DESIGN <i>B</i>	DRAWN BY <i>B</i>	DART AEROSPACE LTD HAWKESBURY, ONTARIO, CANADA		
CHECKED <i>H</i>	APPROVED <i>H</i>	DRAWING NO. DSI 9354		
DATE 06.09.25		REV. A SHEET 1 OF 1 TITLE SHOULDER HARNESS UH-1 BAR SCALE NTS		
A	06.09.25	NEW ISSUE

DART SERVICE INSTRUCTION

TO AMEND INSTALLATION INSTRUCTIONS IIN-D412-702 REV.C AND DSI 9312 REV. B

REF. CANADIAN STC: SH04-7 ISSUE 3
FAA STC: SR01997NY

D3196-5 BAR INSTALLATION (D412-702-011/-013/-021/-023/-033 KITS)

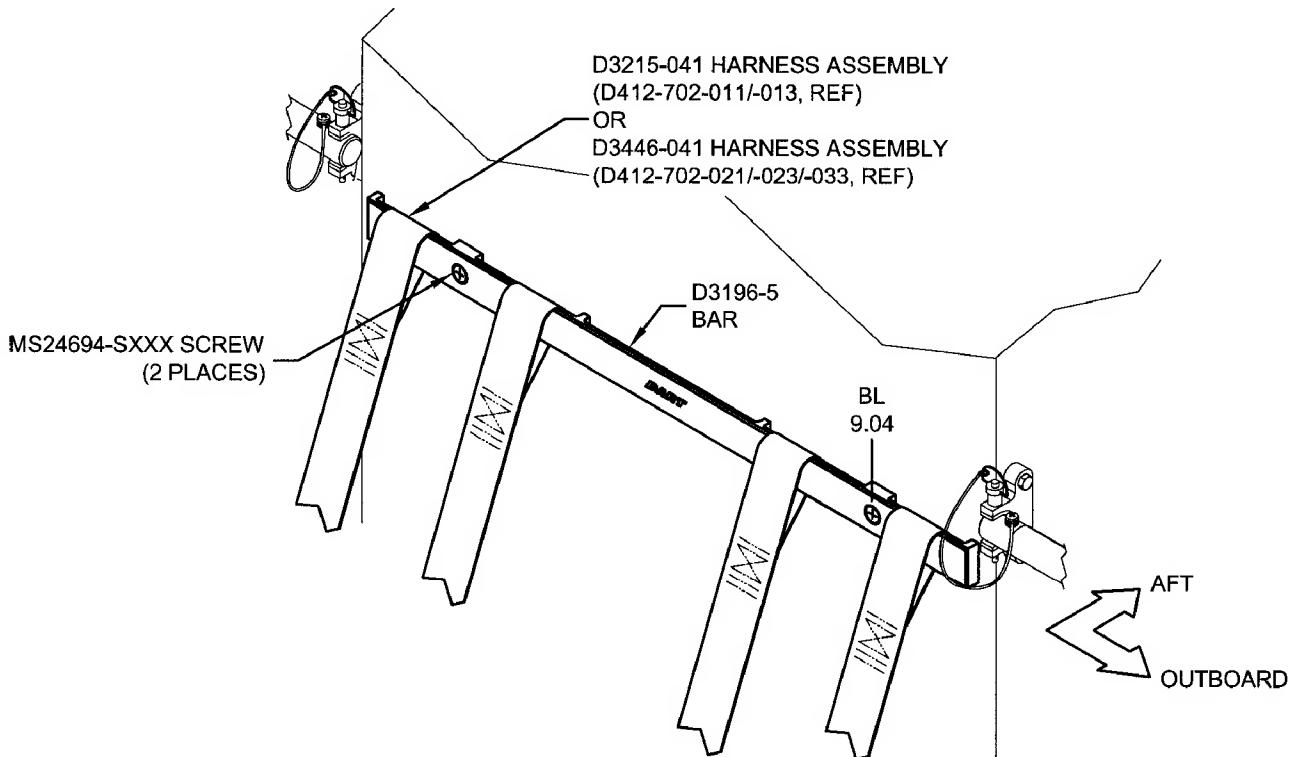
IT IS ACCEPTABLE TO REPLACE P/N D3196-1 BAR FROM THE D412-702-011/-013/-021/-023/-033 KITS WITH D3196-5 TO ALIGN WITH MODIFIED ANCHOR NUT POSITIONS ON SOME UH-1 AIRCRAFT.

WHEN INSTALLING D3196-5 BAR INTO THE AIRCRAFT, IT IS ACCEPTABLE TO USE LONGER MS24694-SXXX SCREWS INSTEAD OF THE MS24694-152 SCREWS CALLED UP IN THE INSTALLATION INSTRUCTIONS IIN-D412-702 TO ENSURE THAT THE BAR IS PROPERLY SECURED.
